Contract Change Order # 1

Project Name: Portland Cement Concrete Street Repair Project Number: Bid No. 16.126 A
 Project Location: City of Broken Arrow Date of Application: Wednesday, May 31, 2017
 Contractor: Cherokee Pride, Inc. Submitted By: COBA

Summary of Change in Scope of Work

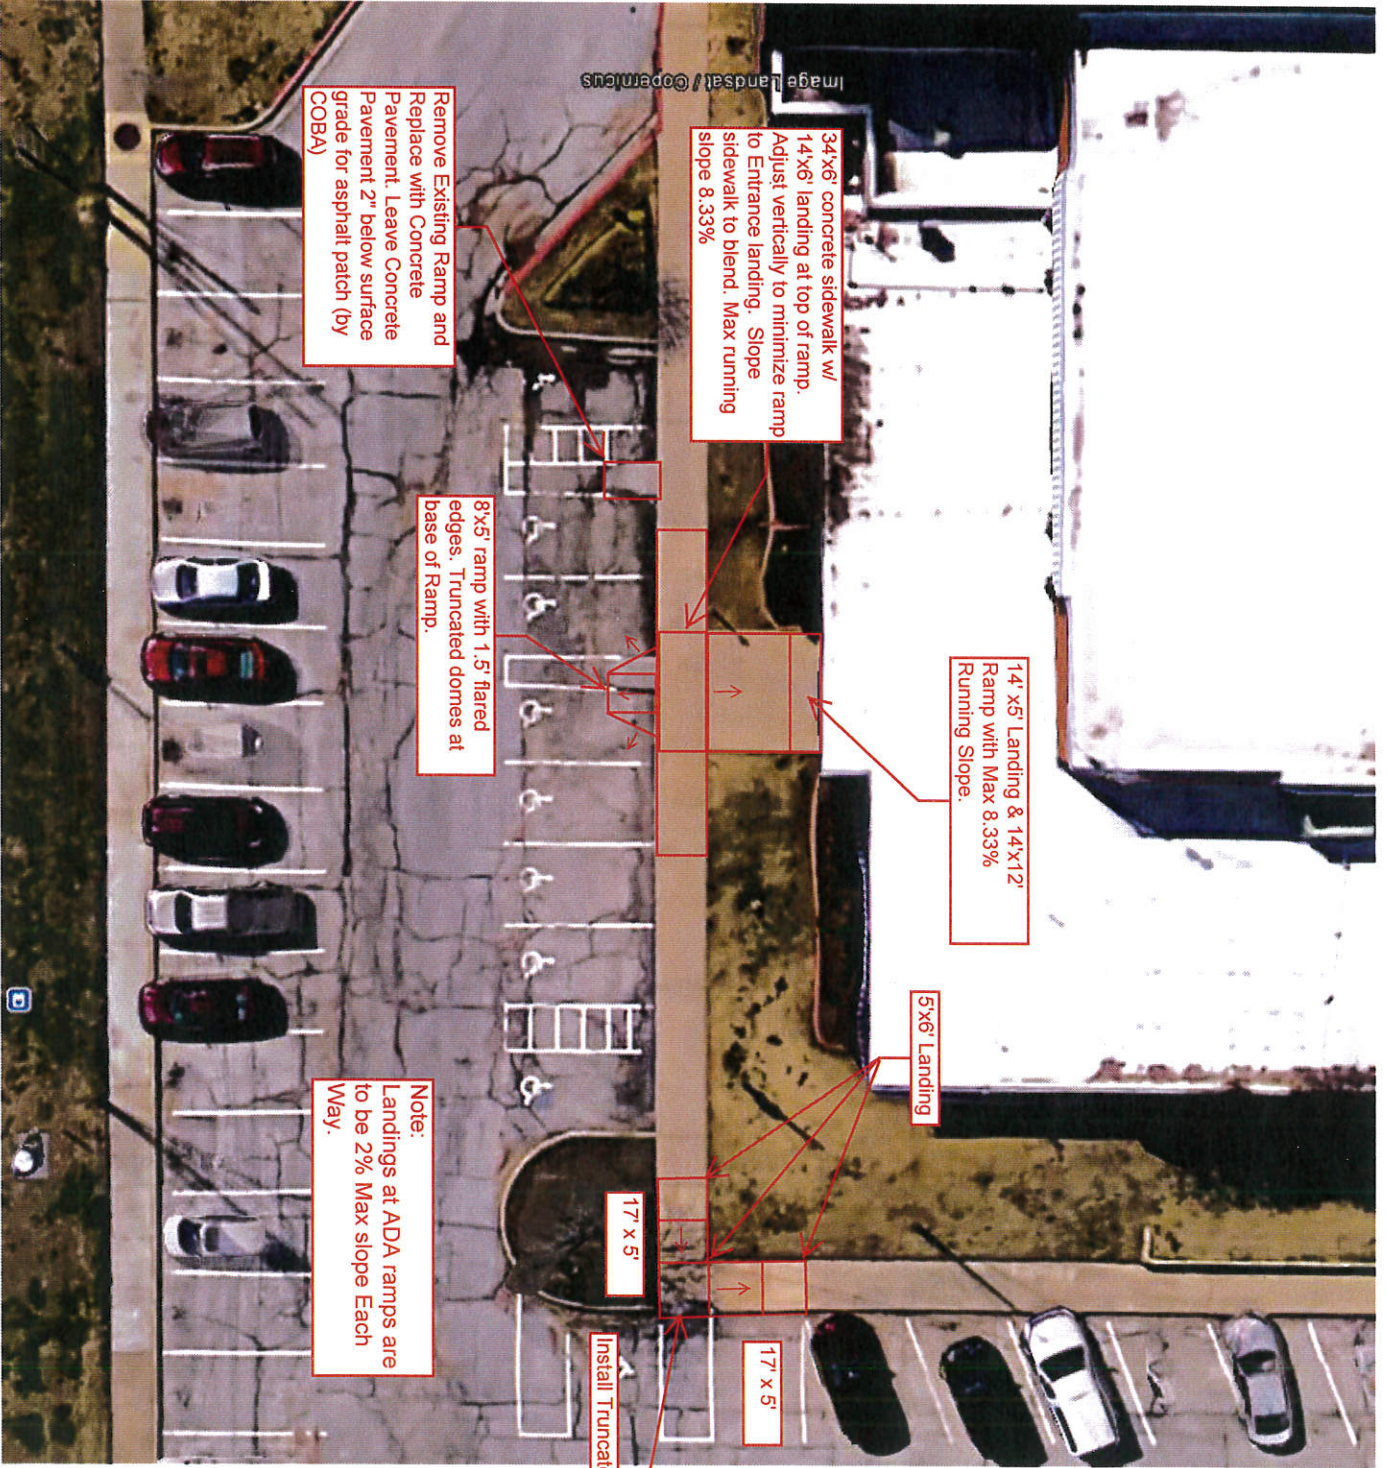
34'x6' concrete sidewalk w/ 14'x6' landing at top of ramp. Adjust vertically to minimize ramp to Entrance landing. Slope sidewalk to blend. Max running slope 8.33%

14' x5' Landing & 14'x12' Ramp with Max 8.33% Running Slope.

5'x6' Landing

8'x5' ramp with 1.5' flared edges. Truncated domes at base of Ramp.

Note: Landings at ADA ramps are to be 2% Max slope Each Way.

Install Truncated Domes

Remove Existing Ramp and Replace with Concrete Pavement. Leave Concrete Pavement 2" below surface grade for asphalt patch (by COBA)

PC Concrete Contract 2016-2017
Work Order - WO-029
Carriage Crossings Sidewalk

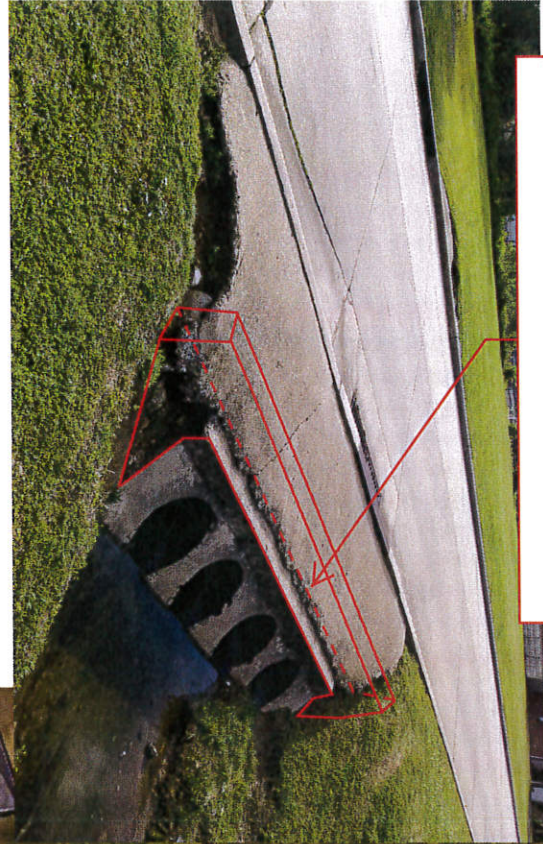
Install 4' sidewalk 250' in length. Maintain offset from roadway edge consistent with remainder of subdivision. See detail at Creek Crossing.

PC Concrete Contract 2016-2017
 Work Order #31 - Work Order Extents

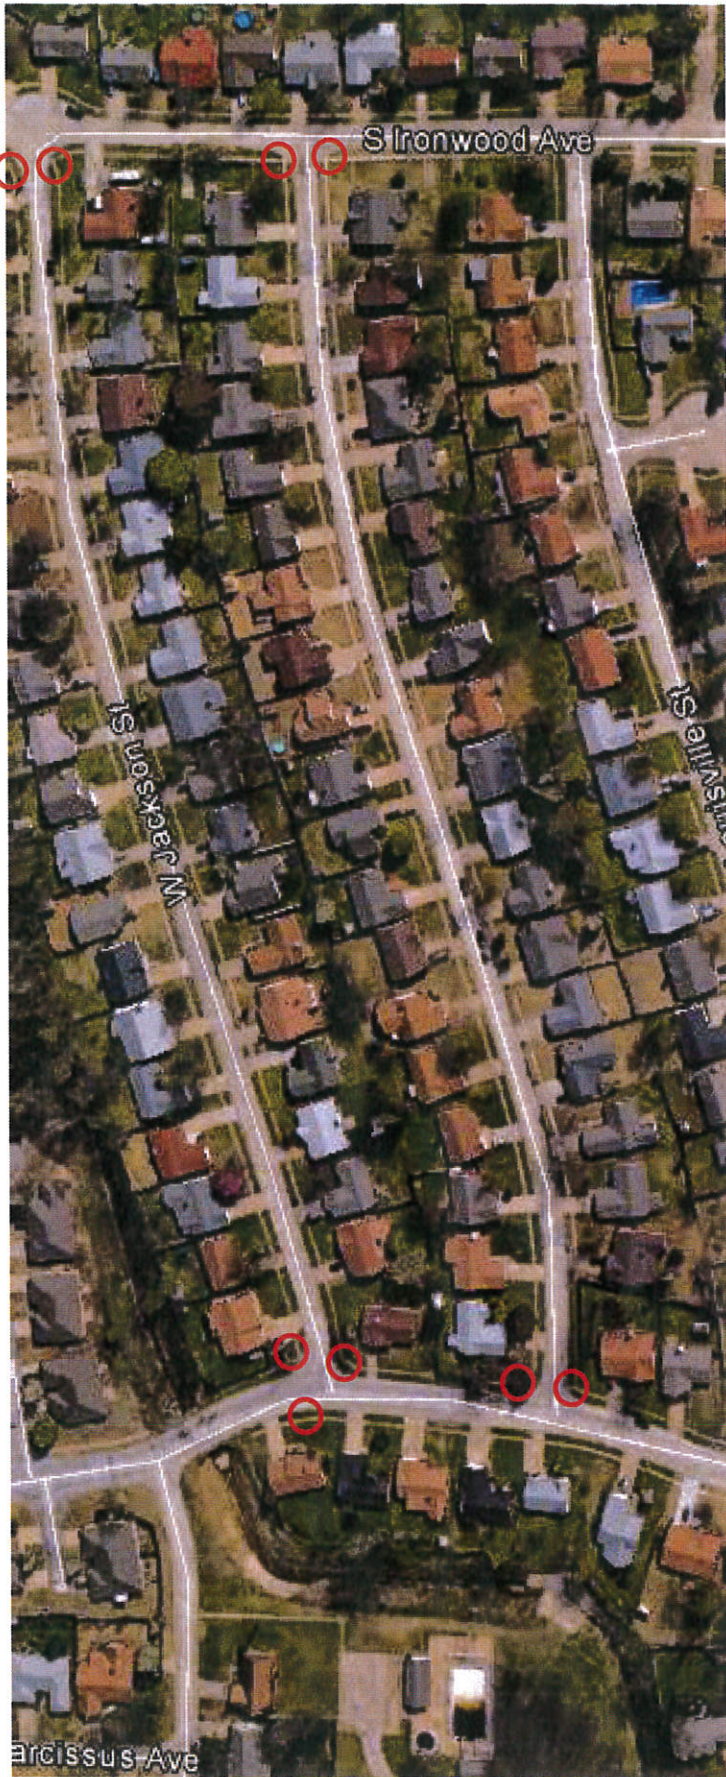
- Install Type "B" ADA Ramps.
- Install sidewalk and curb and gutter as required to make ramp ADA acceptable.

PC Concrete Contract 2016-2017
Work Order #33 - Work Order Extents
Central Park Estates - 81st & Elm

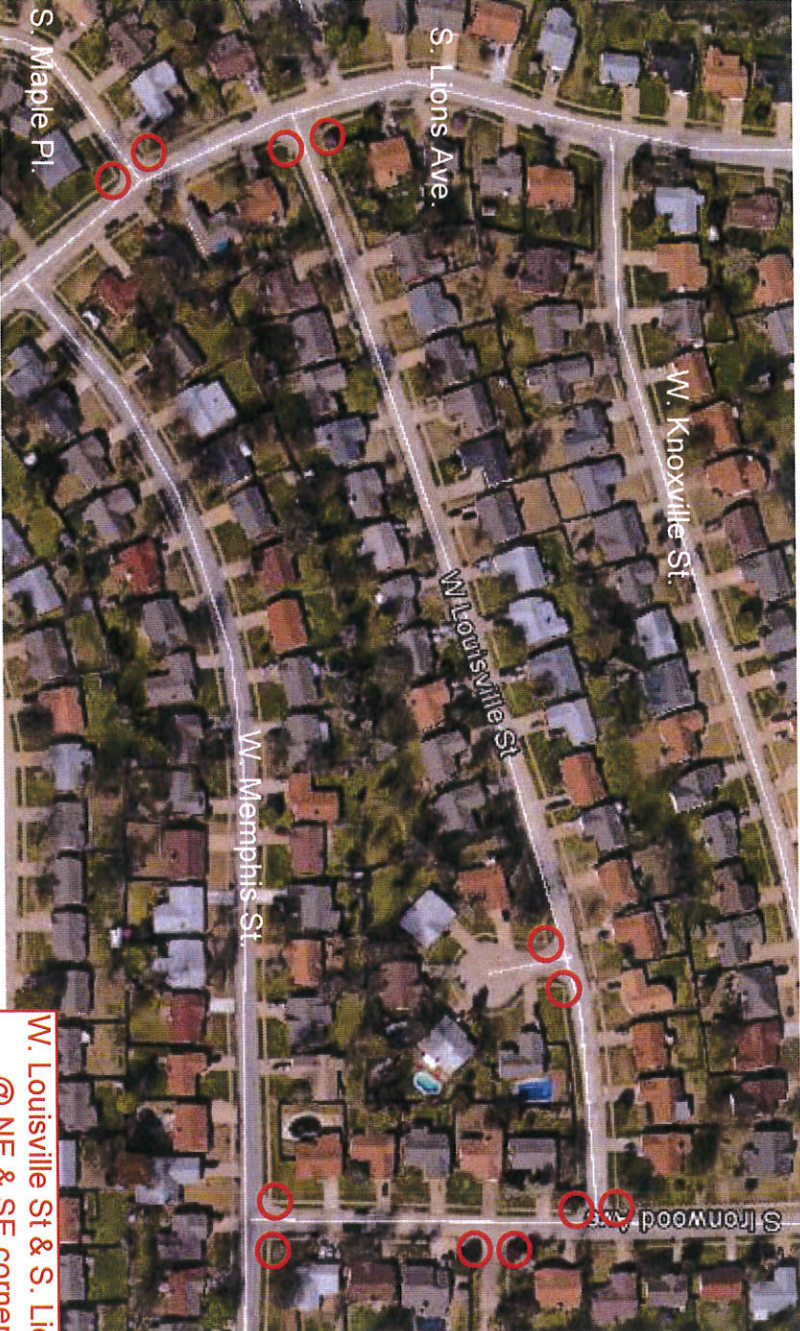
- Install Type "B" ADA Ramps.
- Install sidewalk and curb and gutter as required to make ramp ADA acceptable.

PC Concrete Contract 2016-2017
 Work Order #33 - Work Order Extents
 Central Park Estates - 81st & Elm

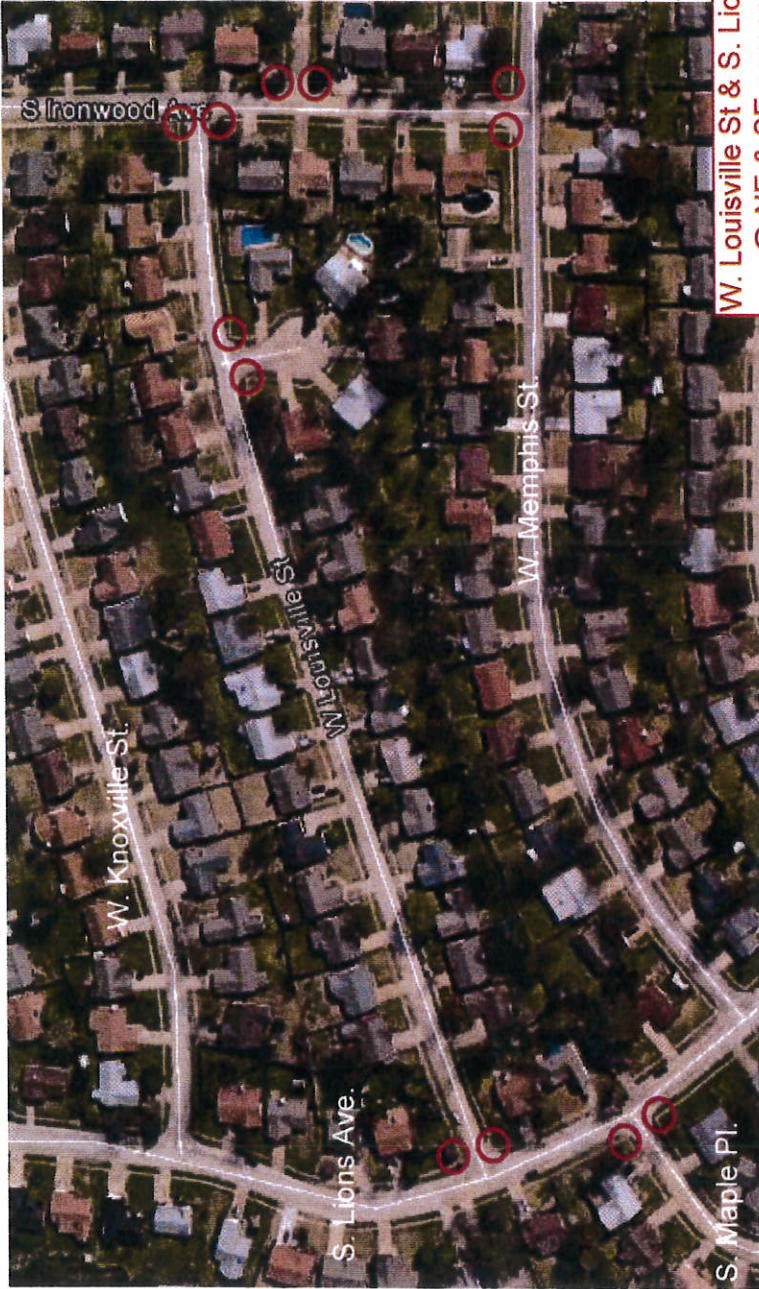
- Install Type "B" ADA Ramps.
- Install sidewalk and curb and gutter as required to make ramp ADA acceptable.

- W. Louisville St & S. Lions Ave.
 @ NE & SE corners
- W. Louisville St. & Ironwood Ave.
 @ NW & SW Corners
- W. Louisville St. @ Deadend Street
 @ NE & SE Corners
- W. Memphis St. & Ironwood Ave.
 @ NW & NE Corners
- S. Maple Pl. & S. Lions Ave.
 @ NW & SW Corners

PC Concrete Contract 2016-2017
Work Order #31 - Work Order Extents

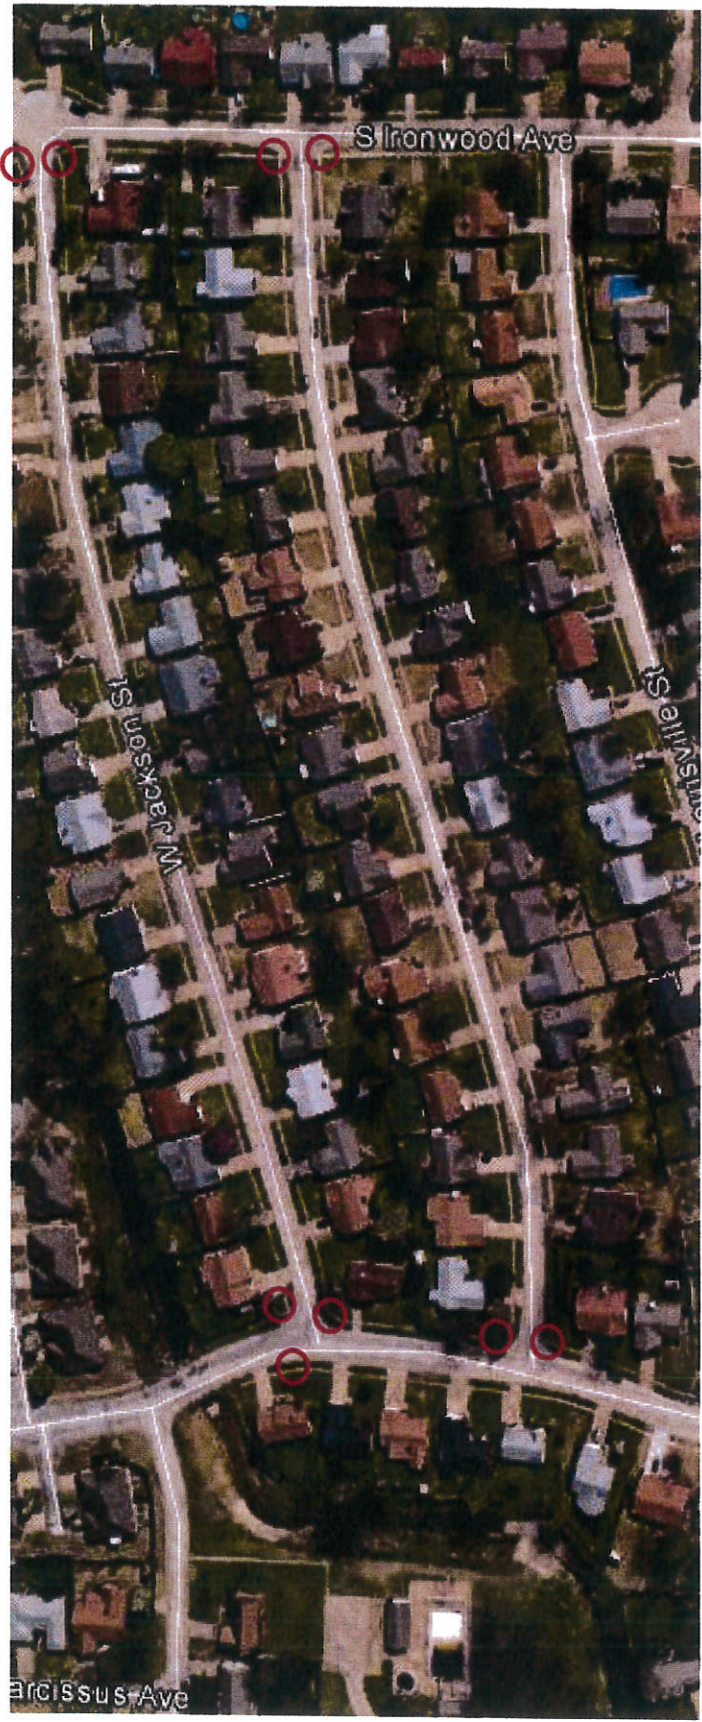
- 809 S. Lions Ave - NW Crm
- 1252 W. Jackson St - SW Crm
- 1101 W. Jackson St. - NE Crm
- 1100 W. Knoxville St. - SE Crm
- 1101 W. Knoxville St. - NE Crm
- 1252 W. Knoxville St. SW Crm
- 901 S. Lions Ave. - NW Crm
- 913 S. Lions Ave. - SW Crm
